June 11, 2024

Re: Response to ARAP Compliance Inspection Letter
NRS21.238 – Blue Oval City
Stanton, Haywood County, Tennessee

Applicant's Response to Compliance Inspection Letter

Figure 1. Modified Impact Map
 Ford Blue Oval
 Haywood County, Tennessee

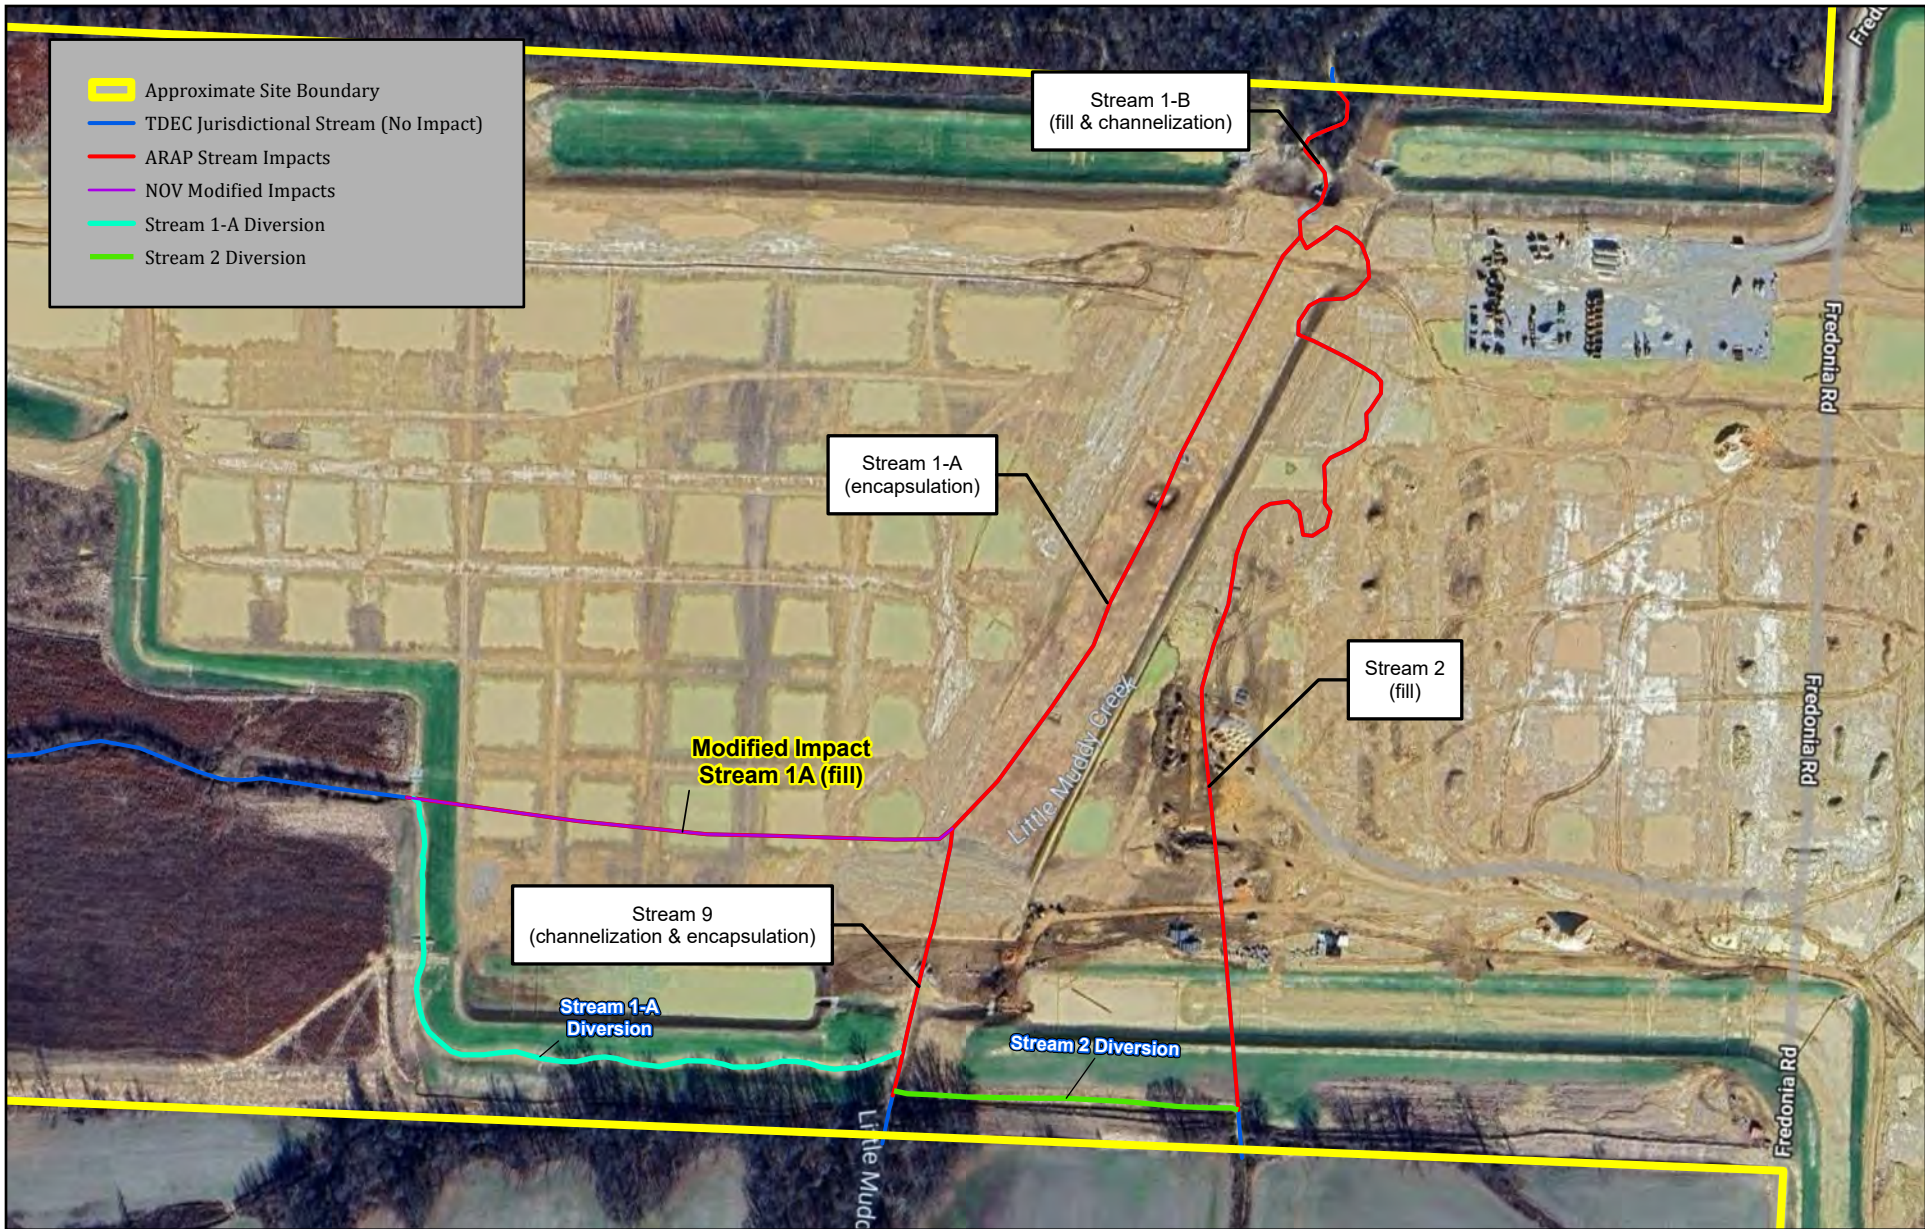
- On or before June 11, 2024, submit the following to the Division:
 - 1) *A detailed plan utilizing data driven methods using aspects of natural channel design that documents elements of the channel such as watershed hydrology, channel hydraulics, sediment transport, lateral site constraints and morphological reference conditions within the ecoregion. The plan should include specific information regarding the linear footage of stream channel for Stream 1-A and Stream 9 that was initially authorized under NRS21.238, information regarding the amount of fill that occurred to either/both channels and specific information regarding the realignment/relocation, including but not limited to linear length.*

- 2) *A 12-point mitigation plan (following Section 5.2.2 of the Division's Stream Mitigation Guidelines) that includes documenting the stream's existing conditions (pre-impact), proposed condition and monitoring requirements. Replacement channels will need to be vegetated, have a natural channel bottom, and have channel stability, both laterally and vertically throughout the monitoring period. Please consult credible sources such as the Natural Resource Conservation Services National Engineering Handbook Stream Restoration Design or the TN Department of Transportation Design Division Drainage Manual, Chapter 11, Natural Stream Design or the Division's Compensatory Mitigation website. The 12-point mitigation plan must use the TNSQT or other scientifically defensible and approve method to determine functional loss and lift of the project. The plan should also include any channel modifications that will be required to meet the Division's Stream Mitigation Guidelines.*

A 4-sided box culvert (12' x 6') was authorized for 2,777 linear feet (LF) on Stream 1-A resulting in a functional loss of -1,160.7 FF. During construction, the downstream portion of the channel (1,567 LF) was encapsulated, and the upstream portion (1,210 LF) was diverted to the south and reconnected with Stream 9 (Figure 1). This modification resulted in 462 cubic yards of fill (0.29 acres). The new channel was constructed similarly to the specifications of Stream 2 (Attachment F of the ARAP application) and the banks were stabilized with annual rye. Based on the ECS values reported in NRS21.238, these modified impacts amount to -1,707.4 FF, resulting in an additional -96.7 FF of loss than that which was accounted for in the ARAP (Table 2). A TNSQT Debit Calculator Tool for Stream 1-A modified impacts is provided in Appendix 2. Mitigation credits generated by the

Cub Creek Mitigation Site to compensate for functional losses under the Blue Oval ARAP are sufficient to cover this additional functional loss. Accordingly, no further compensatory mitigation is required.
